**2 Type of change**

Two laterally positioned notches added to the molding body.

Product Change Notification					PCN - 4797 Cord Retention Notches Added		
owner	creation date	release date	released by	change order no	rev	page	D10-034-720
vetersa	08.07.2019	14.08.2019	limachcl	2017298	B	1 of 2

Old product appearance	New product appearance
<p>Screw-on version</p>  	<p>Screw-on version</p>  
<p>Snap-in version</p> 	<p>Snap-in version</p>

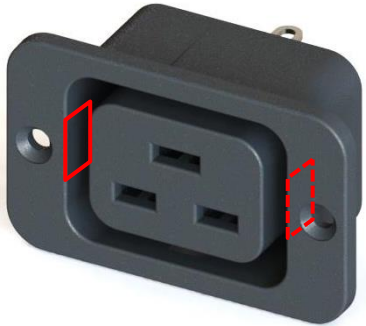
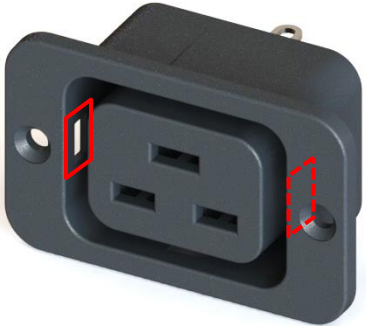
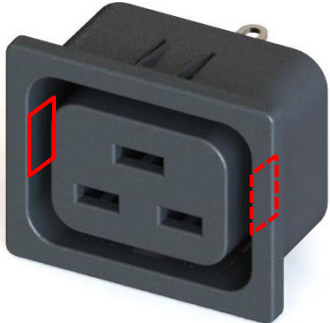
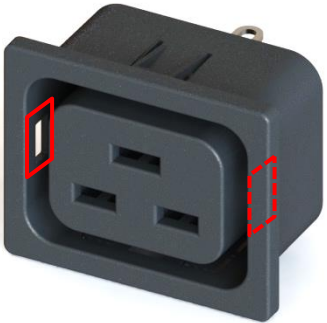
The notches are implemented as a standard feature to be compatible with side latching cord retention systems such as P-Lock, SecureLock or TwyLock.

Form	Yes	Laterally positioned notches. Fully backwards compatible
Fit	No	-
Function	Yes	Compatibility with side latching cord retention systems
Manufacturing	No	-
Label	No	-
Packaging	No	-
